REMARKS

APPENDIX

IN THE DRAWINGS

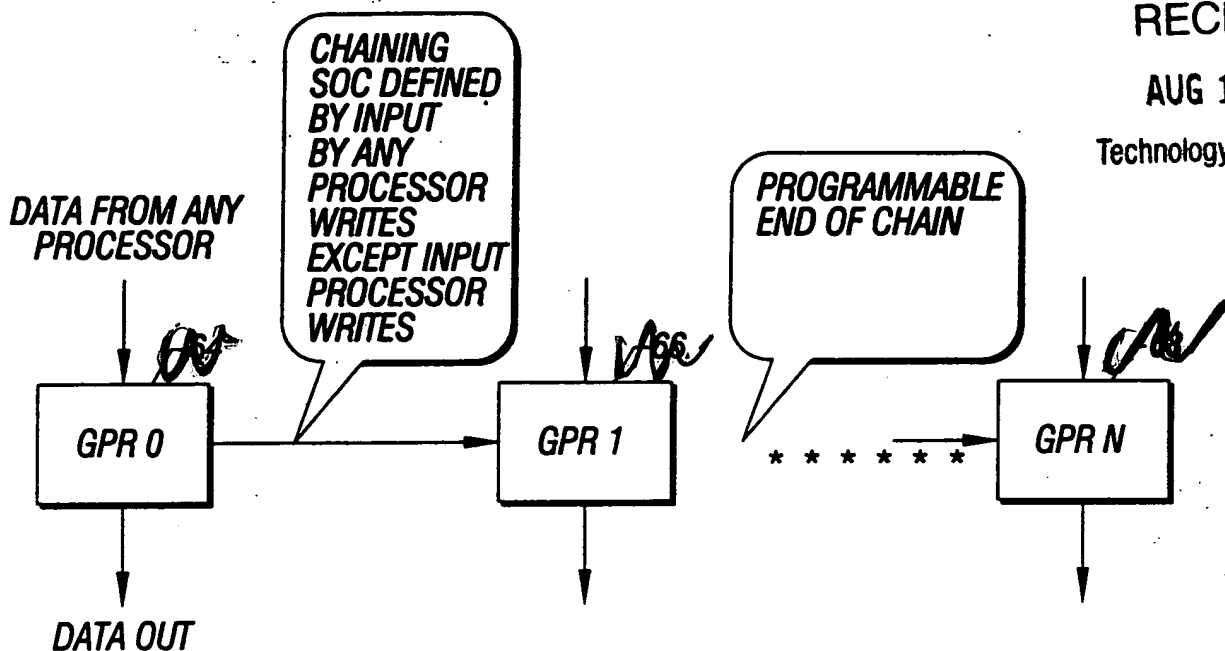
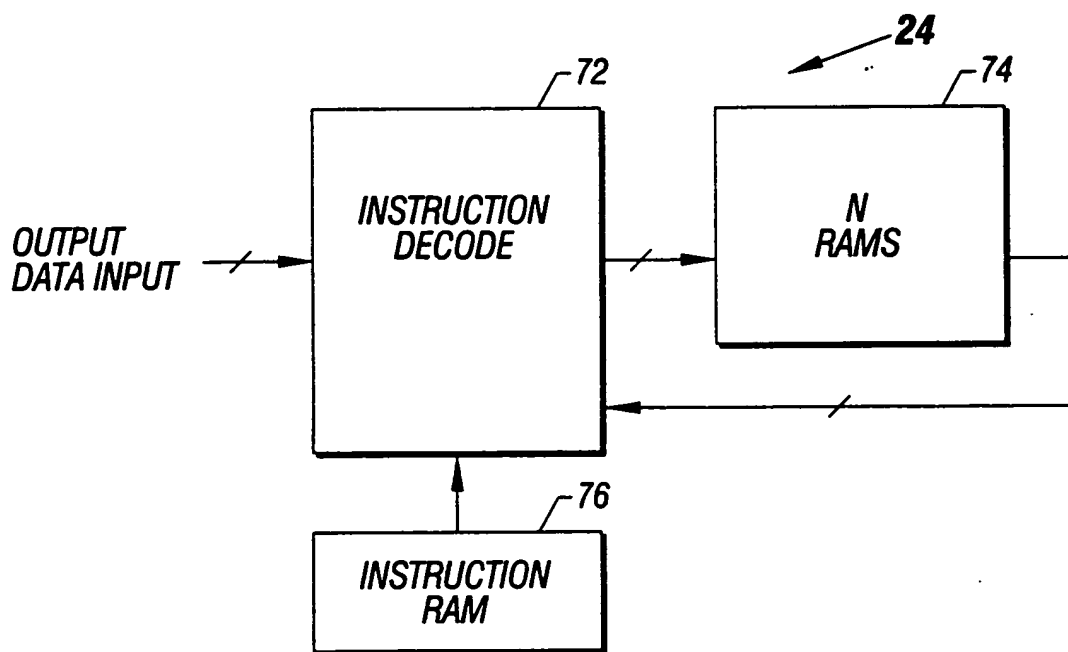
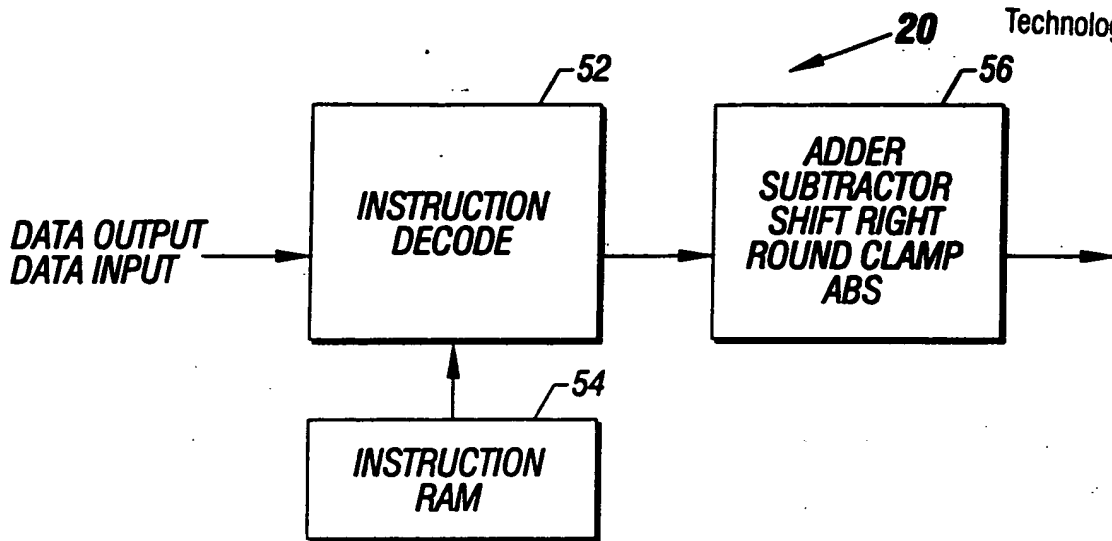
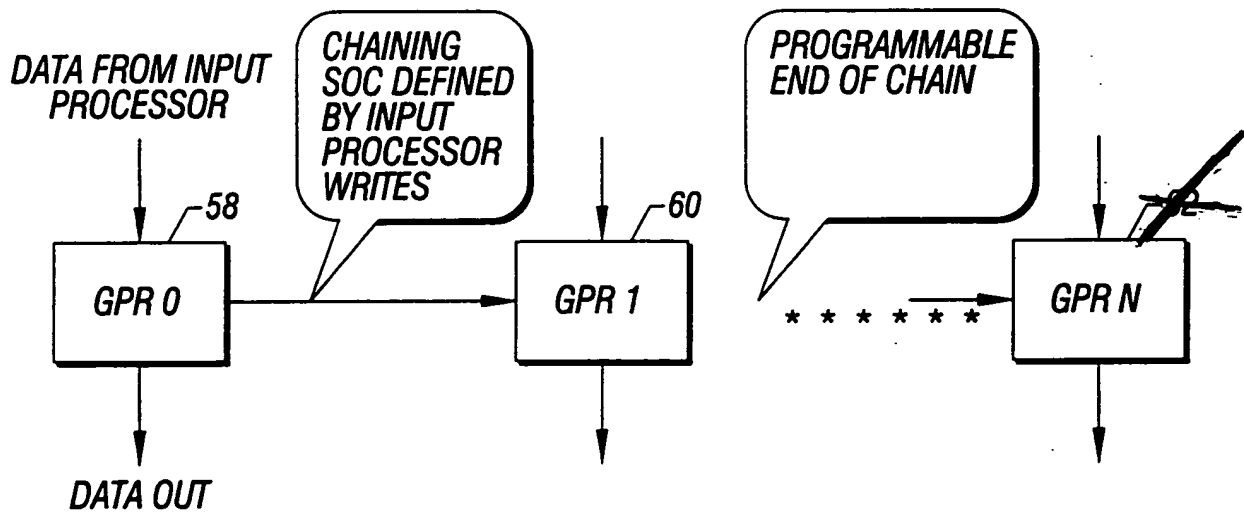
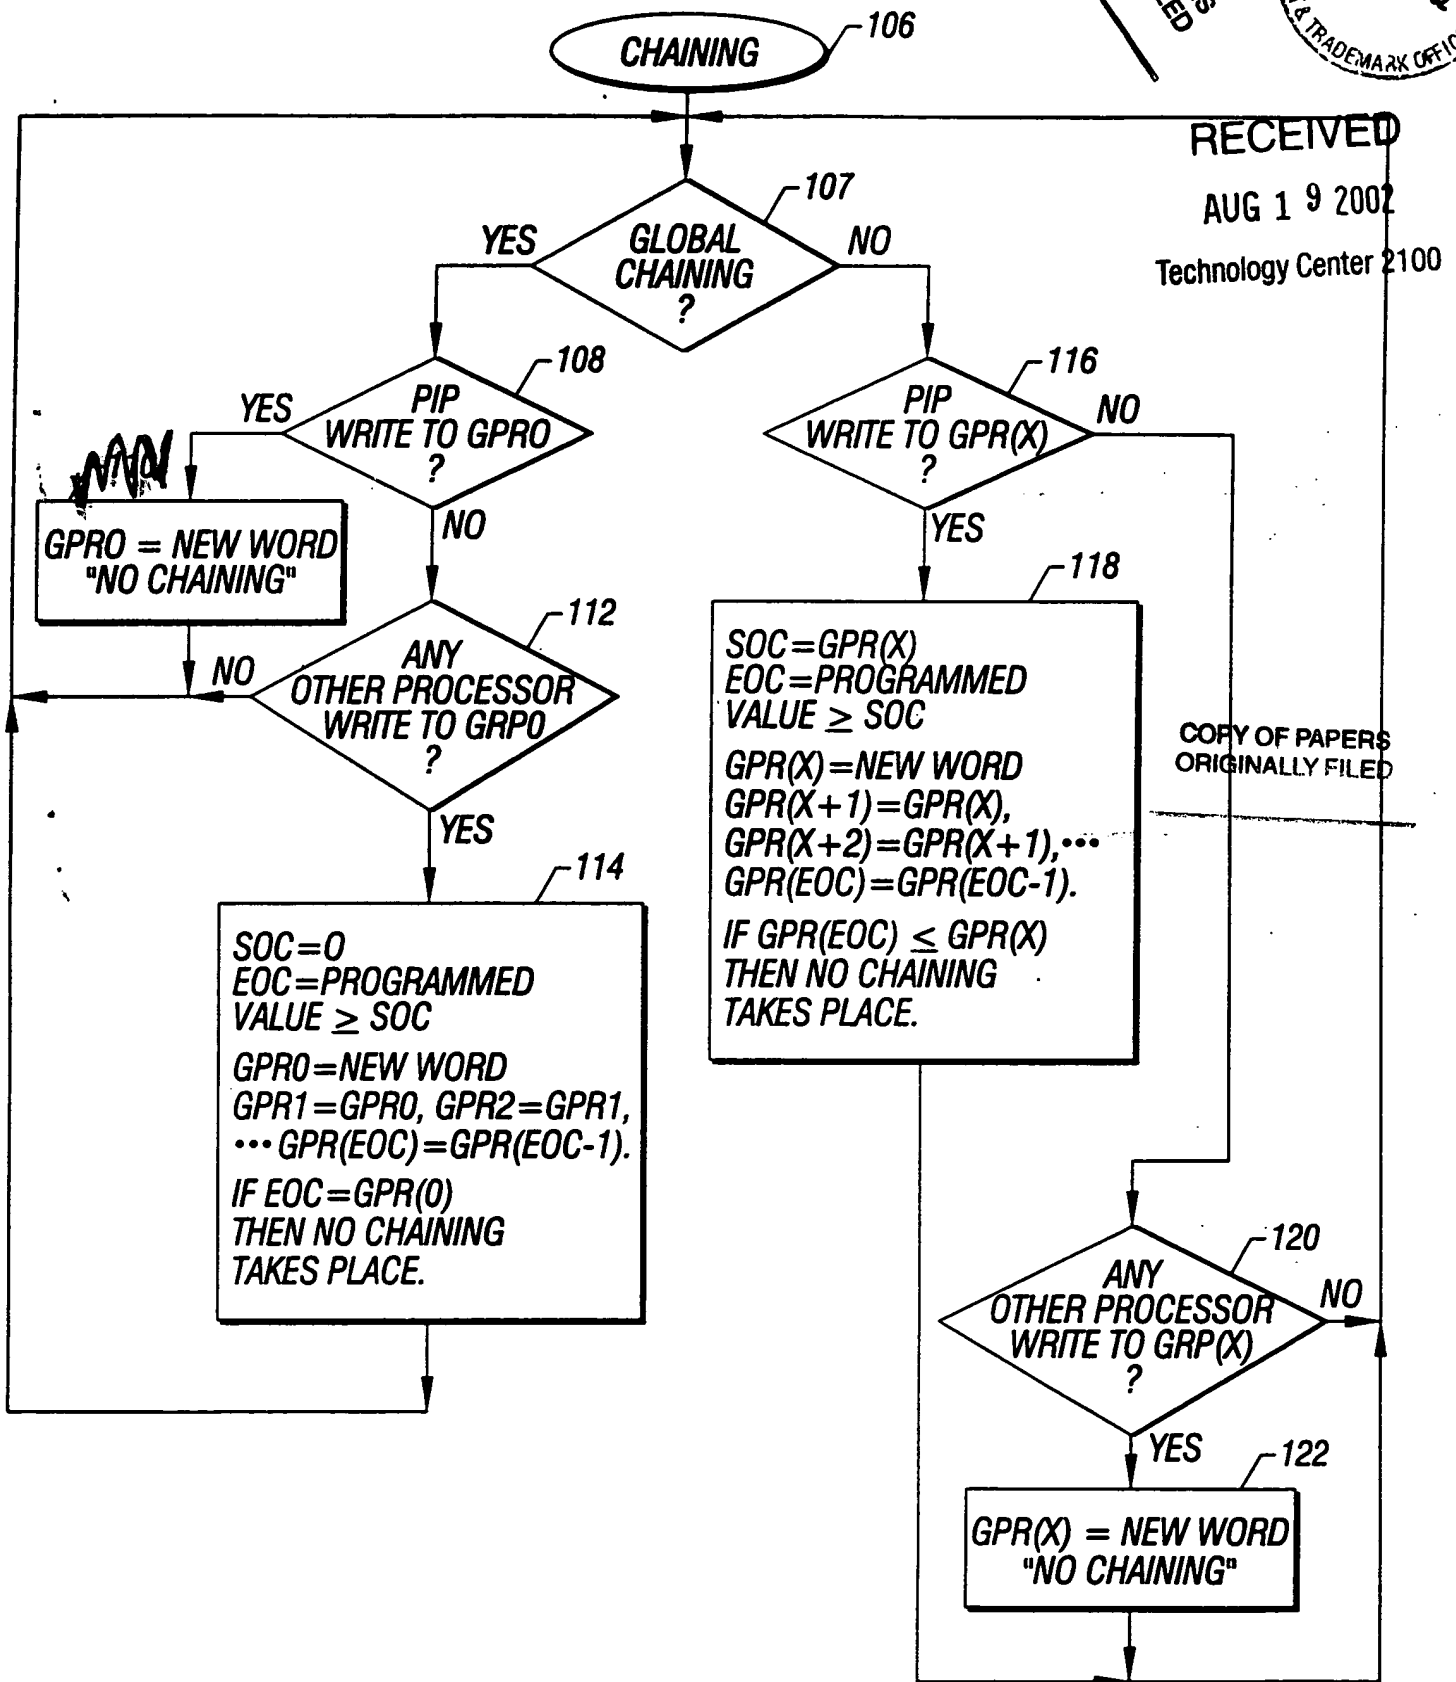
The proposed drawing corrections are indicated in red on the attached sheets.
